In the Matter of Transfer Application	)	FINAL ORDER APPROVING A CHANGE IN
T-13888, Lane County	)	POINTS OF APPROPRIATION

In the Matter of Transfer Application	)	PRELIMINARY DETERMINATION
T-13888, Lane County	)	PROPOSING APPROVAL OF A CHANGE IN
	)	POINTS OF APPROPRIATION

Once the Preliminary Determination is issued a publication period is required. Because there is more than ¼ mile between the new and the authorized points of appropriation the Department

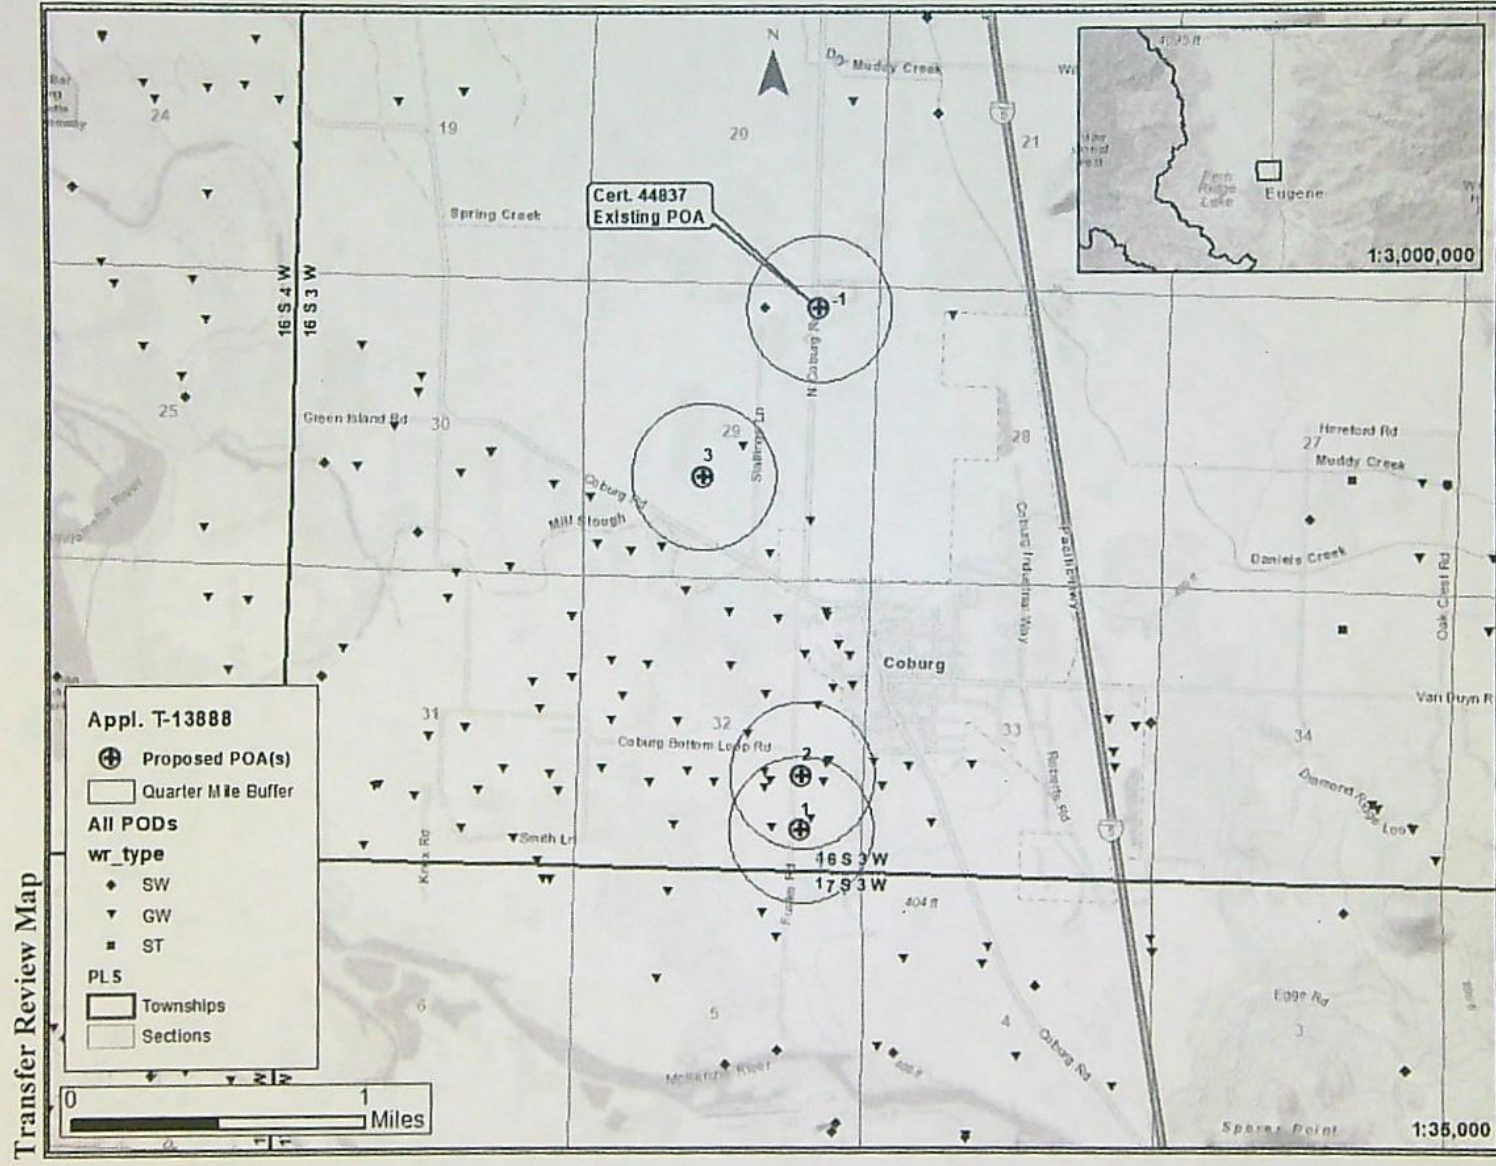
4. a) Will this proposed change, at its maximum allowed rate of use, likely result in an increase in interference with **another ground water right**?
☒ Yes ☐ No Comments: The proposed change would move appropriation under Cert. 44837 closer to several existing groundwater rights

5. a) Will this proposed change, at its maximum allowed rate of use, likely result in an increase in interference with **another surface water source**?
☒ Yes ☐ No Comments: The proposed change would move the POAs under the existing certificate closer to the McKenzie River which would increase hydraulic interference with surface water.

- b) If yes, at its maximum allowed rate of use, what is the expected change in degree of interference with any **surface water sources** resulting from the proposed change?
Stream: McKenzie River ☒ Minimal ☐ Significant
Provide context for minimal/significant impact: _____

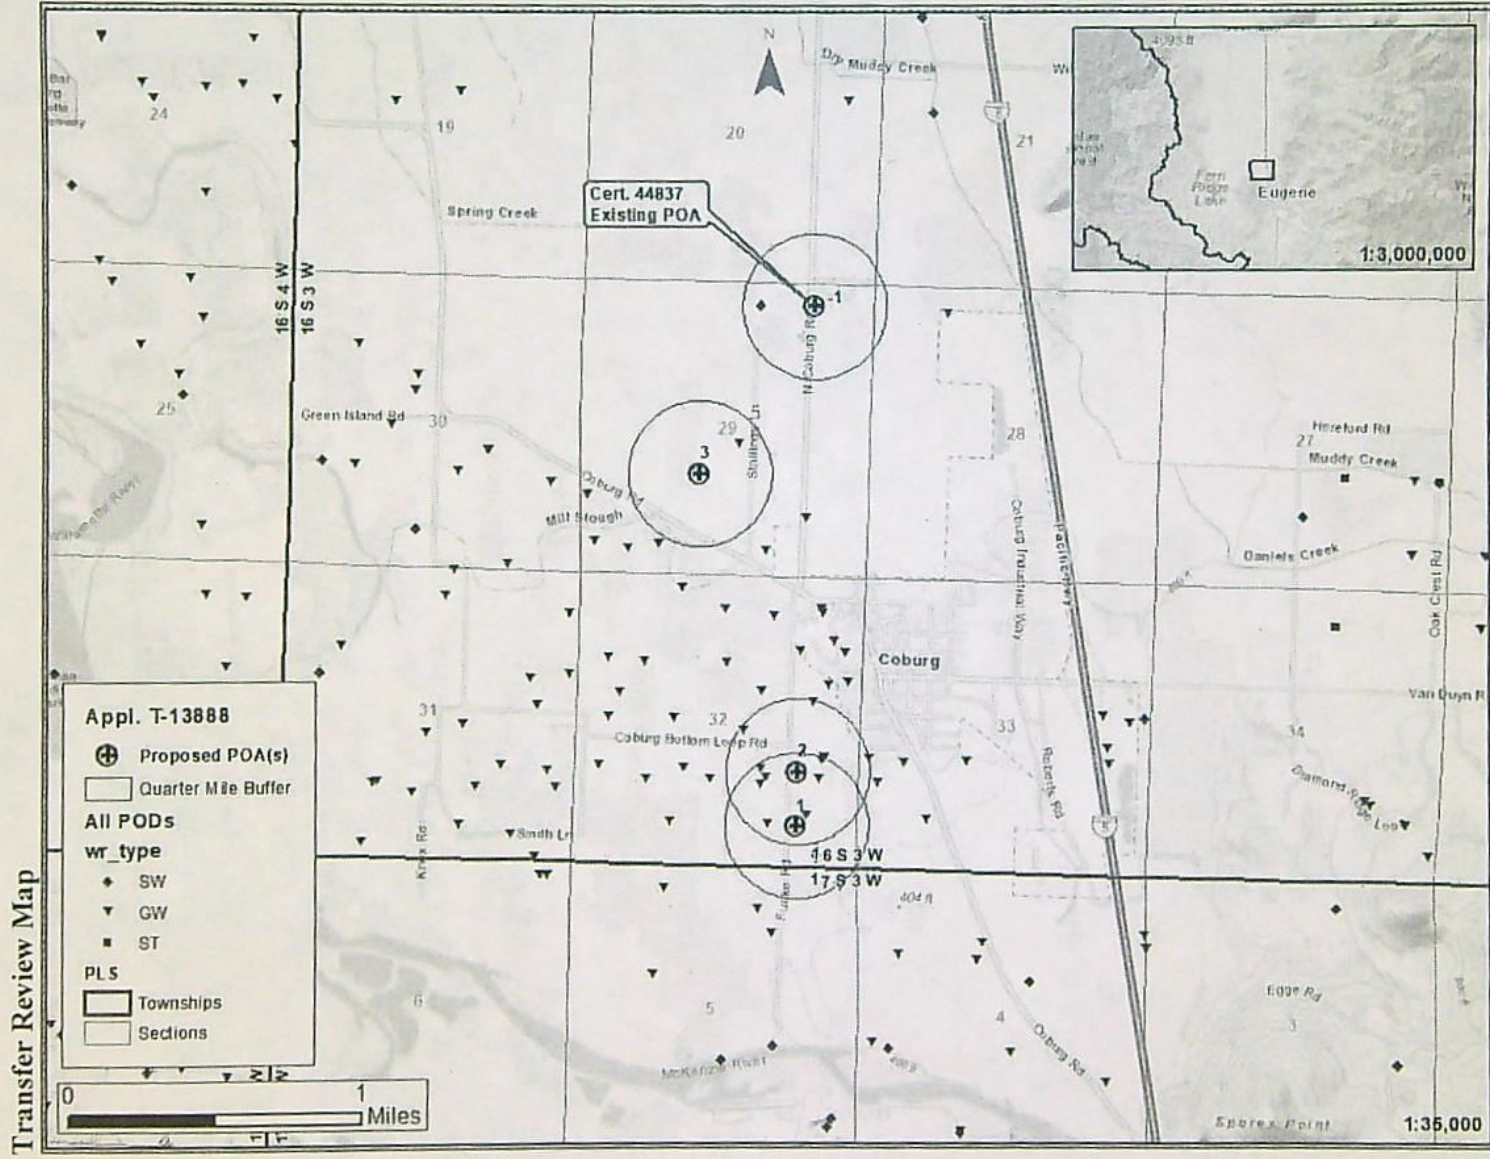
4. a) Will this proposed change, at its maximum allowed rate of use, likely result in an increase in interference with **another ground water right**?
☒ Yes ☐ No Comments: The proposed change would move appropriation under Cert. 44837 closer to several existing groundwater rights

5. a) Will this proposed change, at its maximum allowed rate of use, likely result in an increase in interference with **another surface water source**?
☒ Yes ☐ No Comments: The proposed change would move the POAs under the existing certificate closer to the McKenzie River which would increase hydraulic interference with surface water.

- b) If yes, at its maximum allowed rate of use, what is the expected change in degree of interference with any **surface water sources** resulting from the proposed change?
Stream: McKenzie River ☒ Minimal ☐ Significant
Provide context for minimal/significant impact: _____
